ADDENDUM

ADDENDUM NO.: **01**

PROJECT NAME: **Lake View High School Renovation Project**

DATE OF ISSUE: **April 19, 2017**

6 BOILER PACKAGED FEED WATER CONDENSATE TANK SYSTEM DETAIL

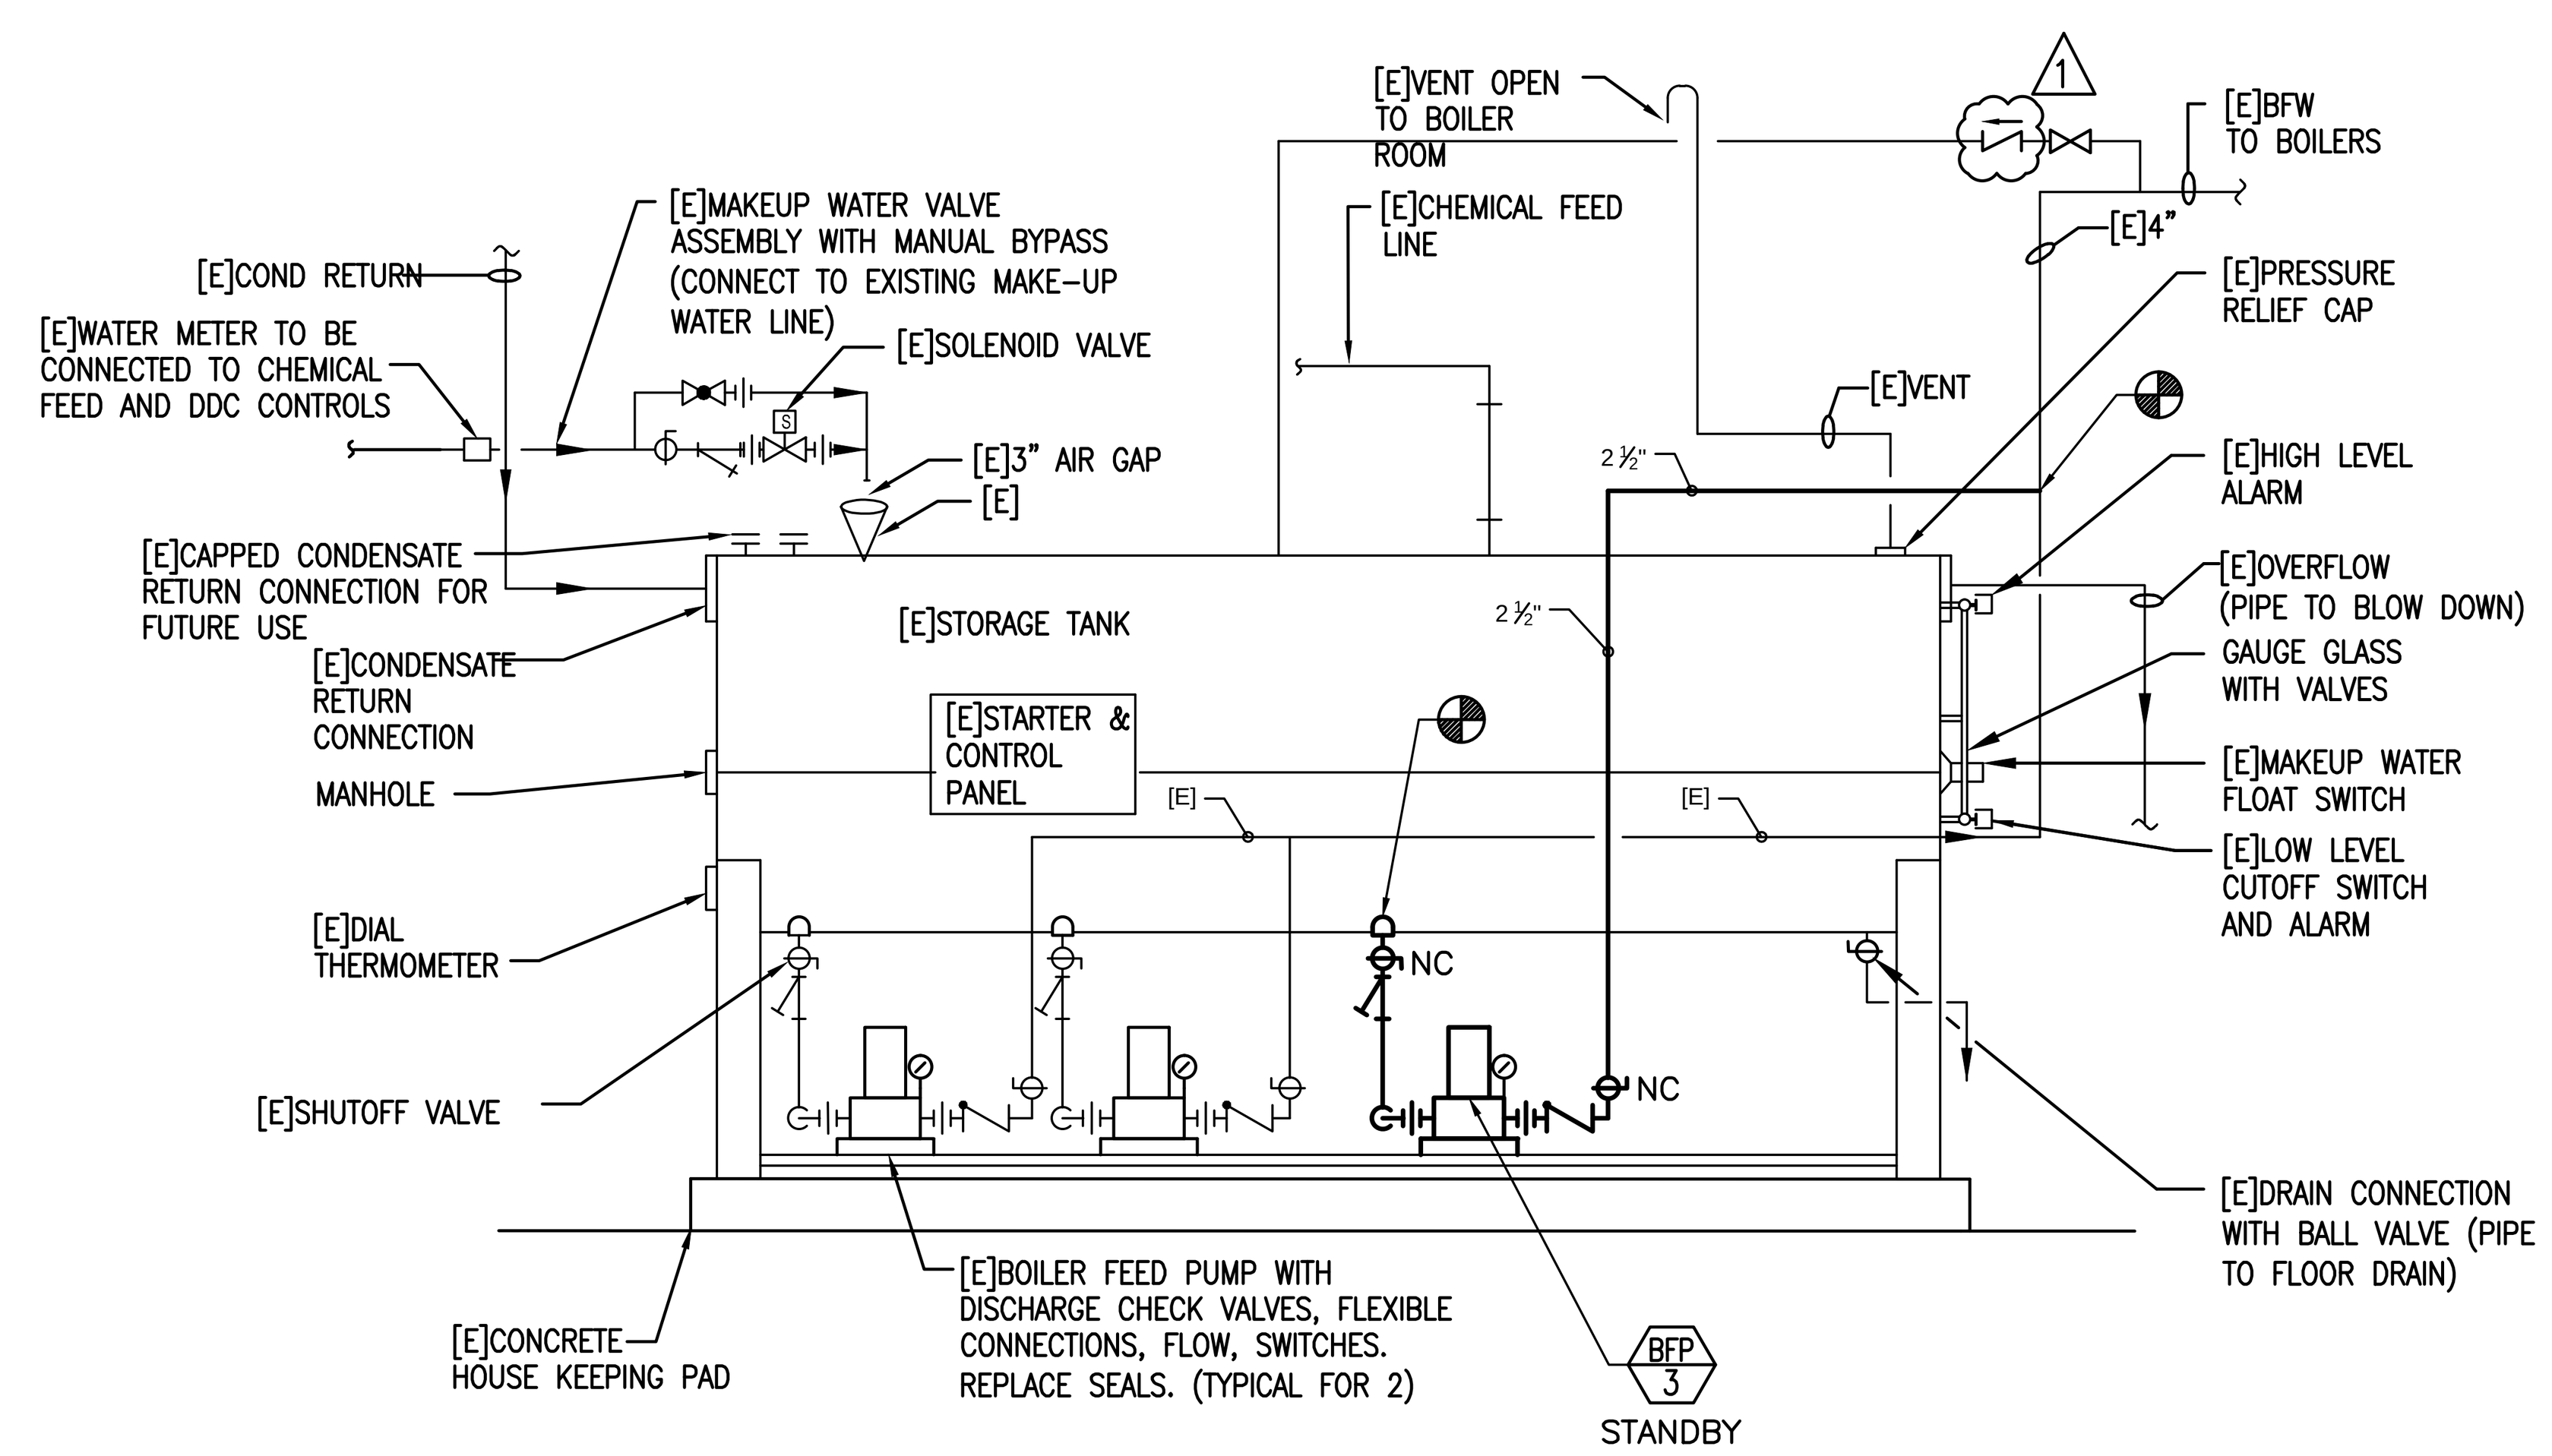
u. **REVISED** Drawing No. M3.1, MECHANICAL SCHEDULES: Changed Fans EF-6 & EF-7 locations in Fan Schedule.
v. **REVISED** Drawing No. M4.1, MECHANICAL DETAILS: Condensate Tank System detail 6 revised.

M4.2

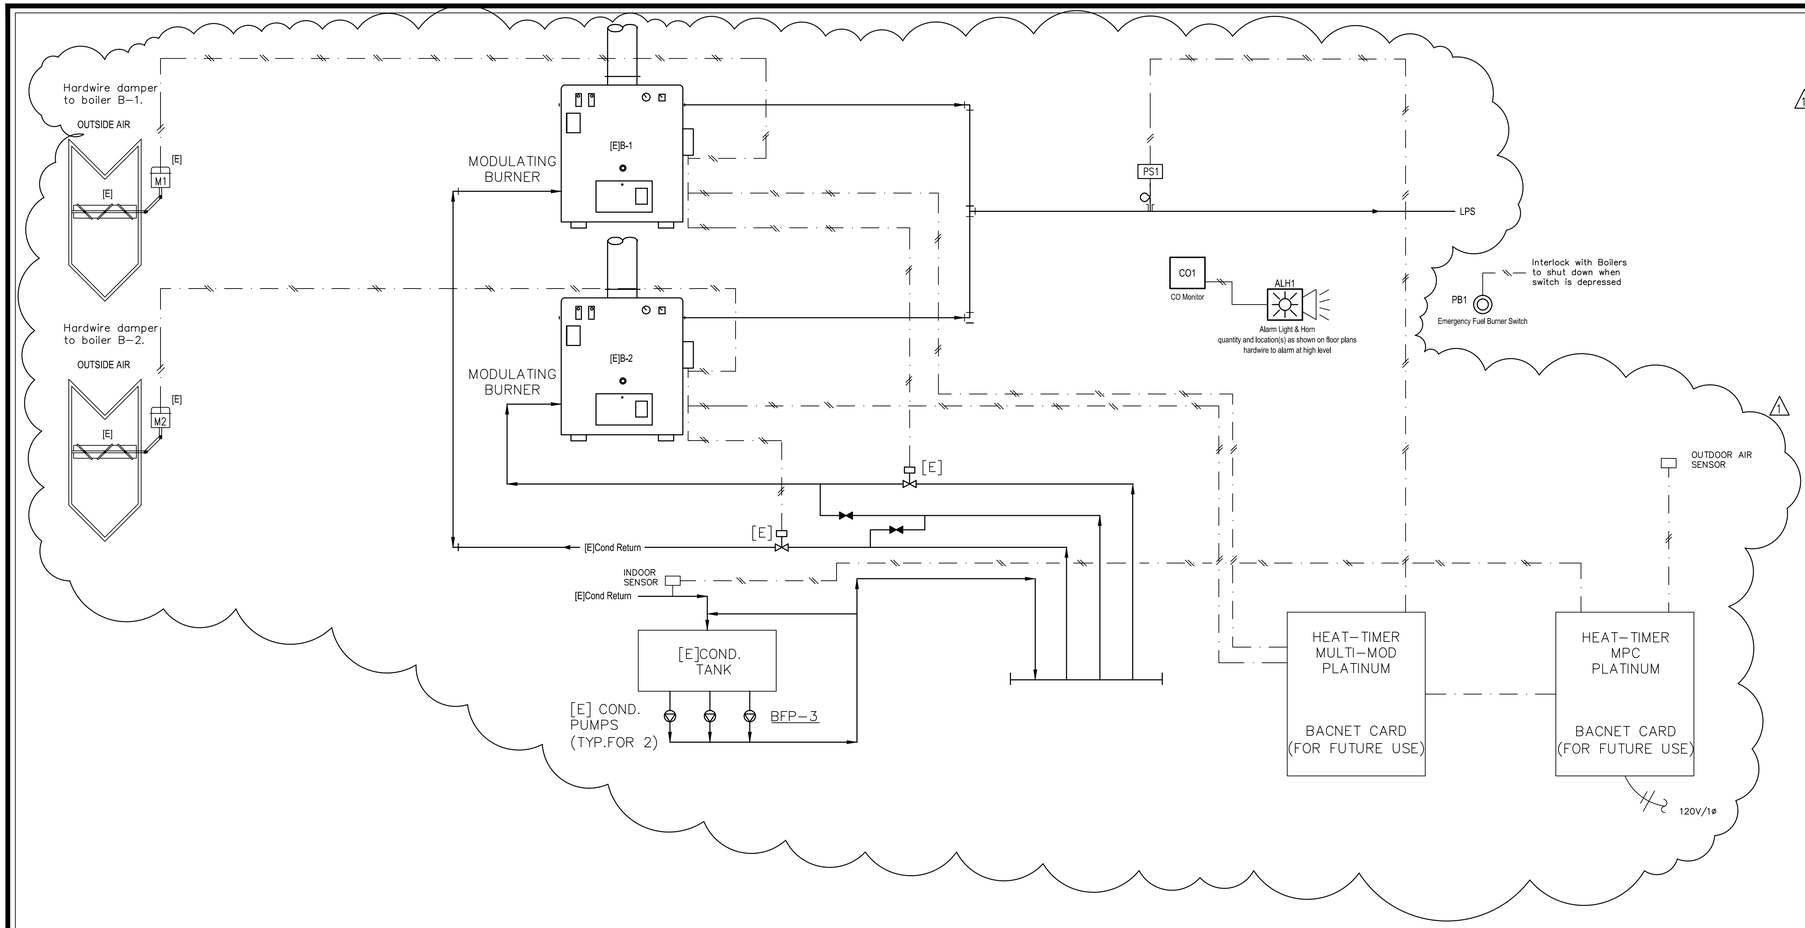
w. **REVISED** Drawing No. M4.2, STEAM BOILER SYSTEM SYMBOLS: Sheet title revised and boiler riser added.

1 PLUMBING PIPING RISER DIAGRAMS
NTS

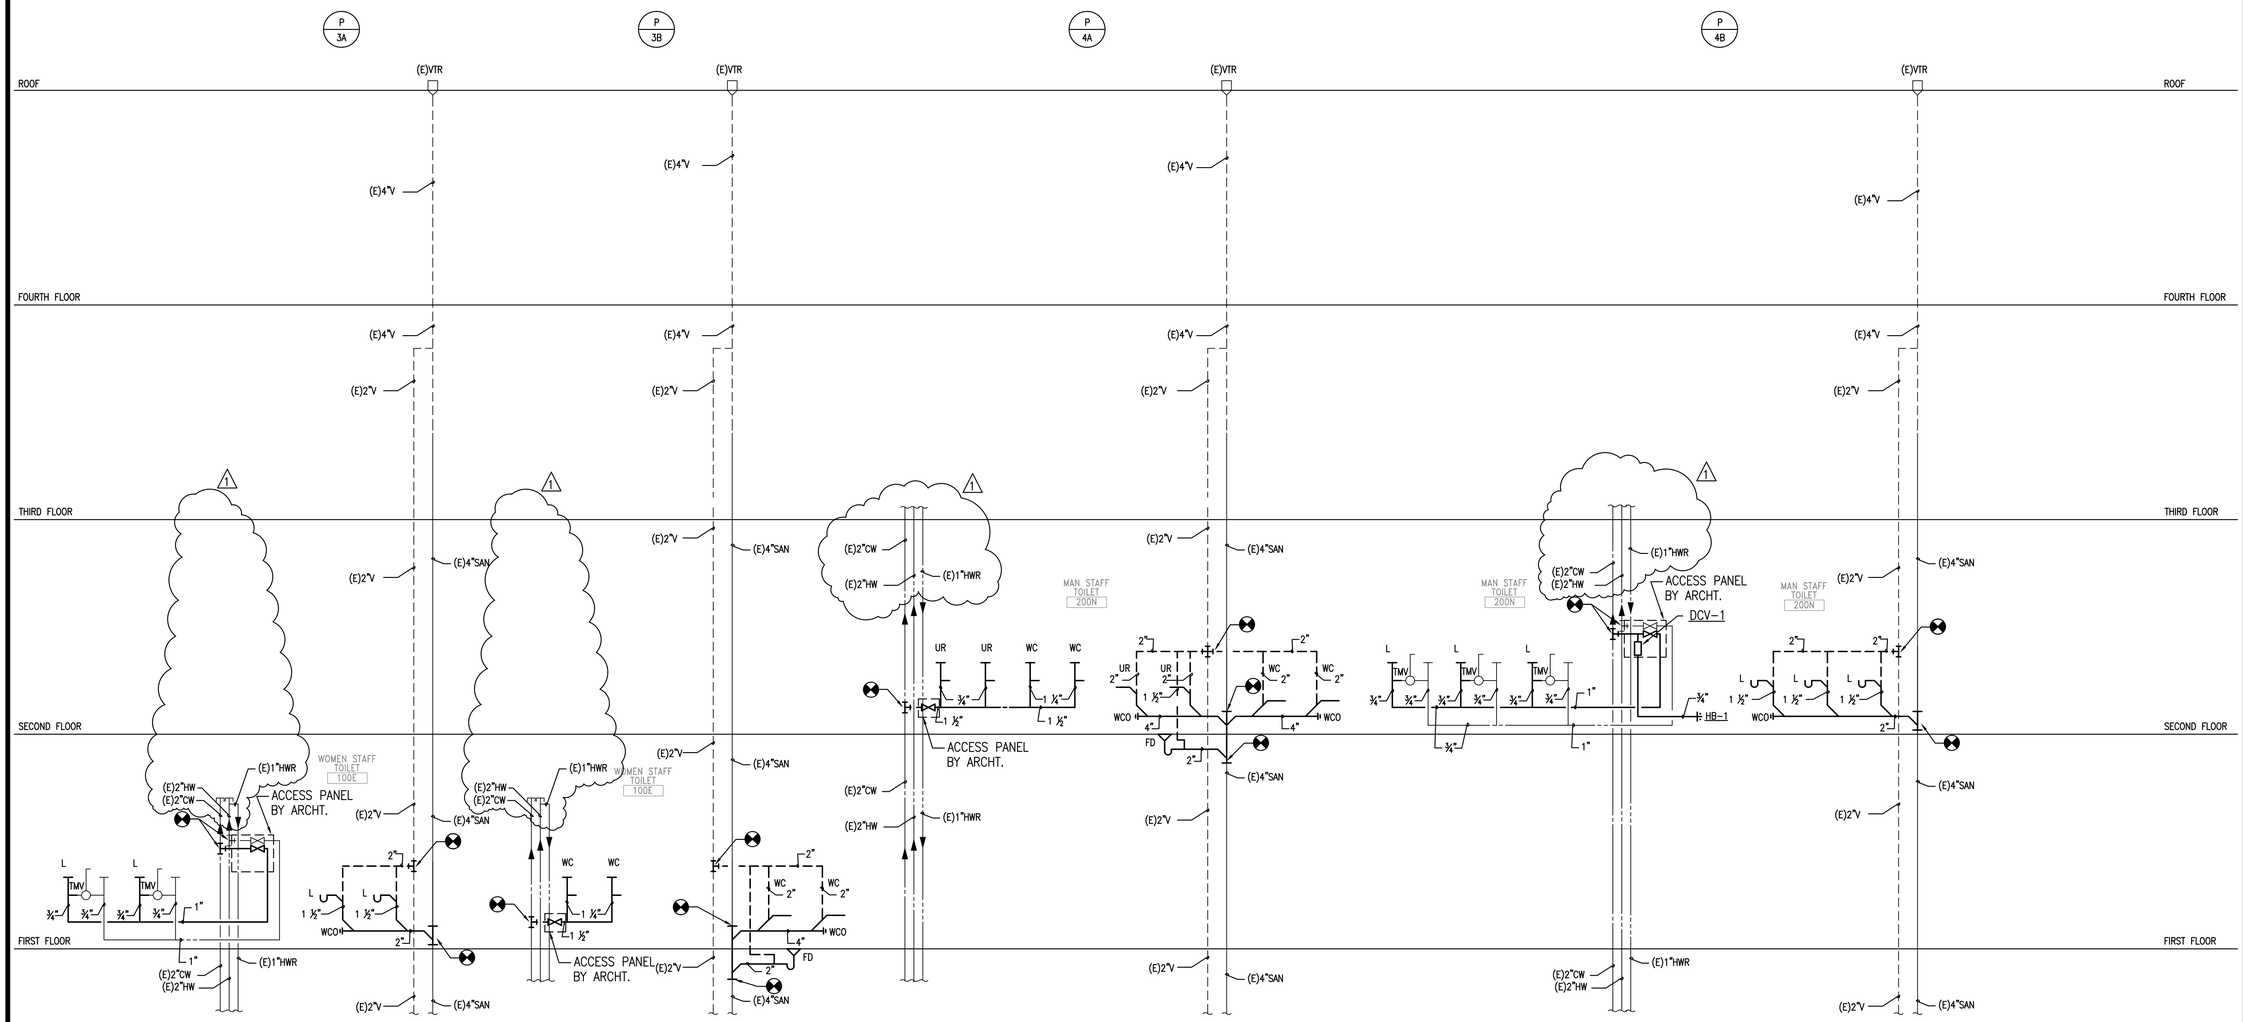
x. **REVISED** Drawing No. P3.2, PLUMBING PIPING RISER DIAGRAMS: Detail 1 – Plumbing Piping Riser Diagrams modified.
y. **REVISED** Drawing No. E0.0, ELECTRICAL SYMBOLS LIST: Added symbols.

C2.0

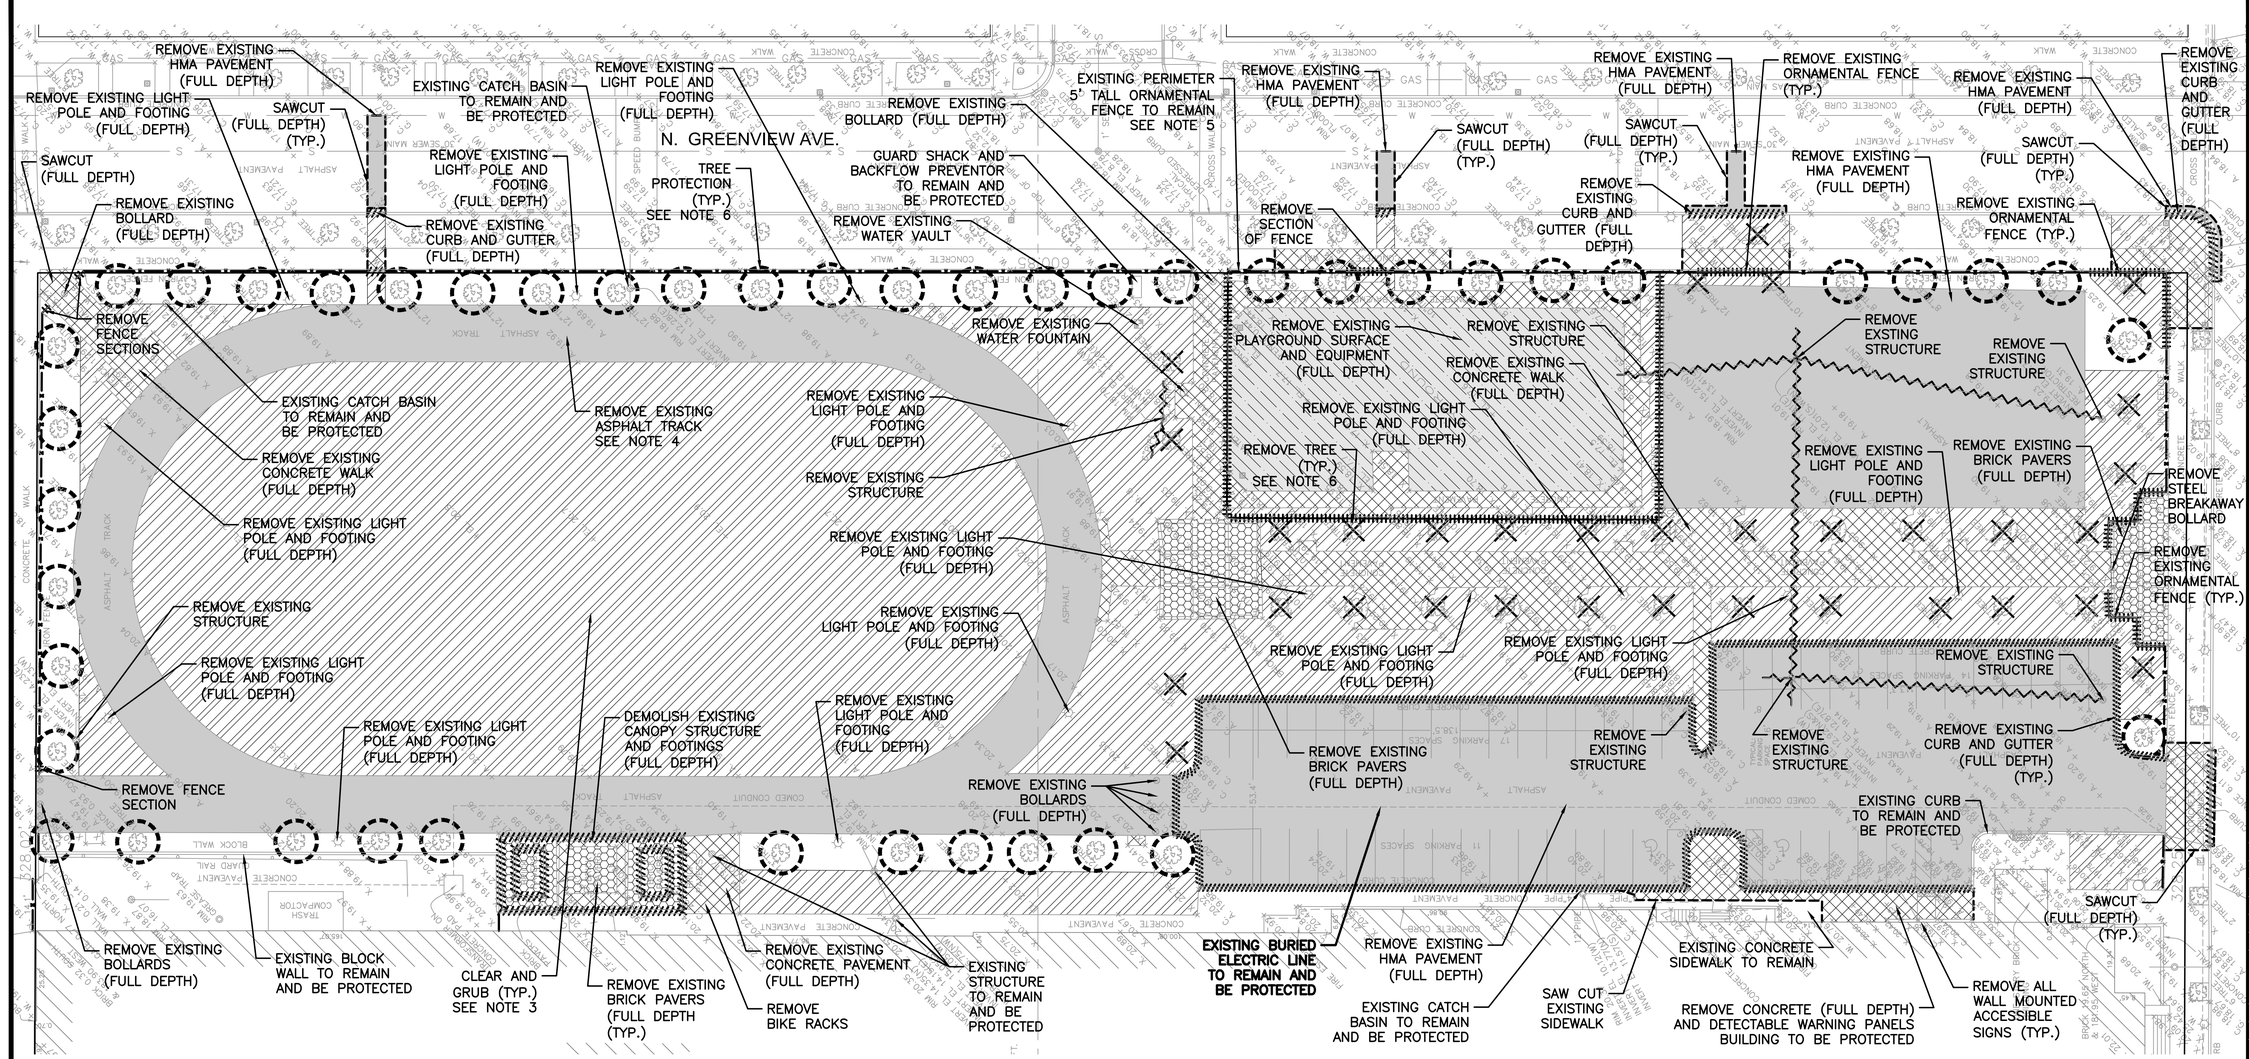
a. **REVISED** Drawing No. C2.0, Demolition Plan. Note 3 revised.
b. **REVISED** Drawing No. C3.0, Site Plan. Detail 2/C7.7 removed.
c. **REVISED** Drawing No. C3.1, Enlarged Site Plan. Detail 5/C3.1 revised.
d. **REVISED** Drawing No. C7.4, Details. Detail 6/C7.4 removed.
e. **REVISED** Drawing No. C7.7, Details. Details 2/C7.7, 3/C7.7, and 4/C7.7 removed.

Statements: Regarding Site Demolition - Drawing No. C2.0: Will the Decorative Benches be removed and disposed of or removed and salvaged?

Response: Existing precast benches, and tables w/benches, to be removed and salvaged. Refer to Sheet C2.0 Demolition Plan, Note 3 of this Addendum No. 01.
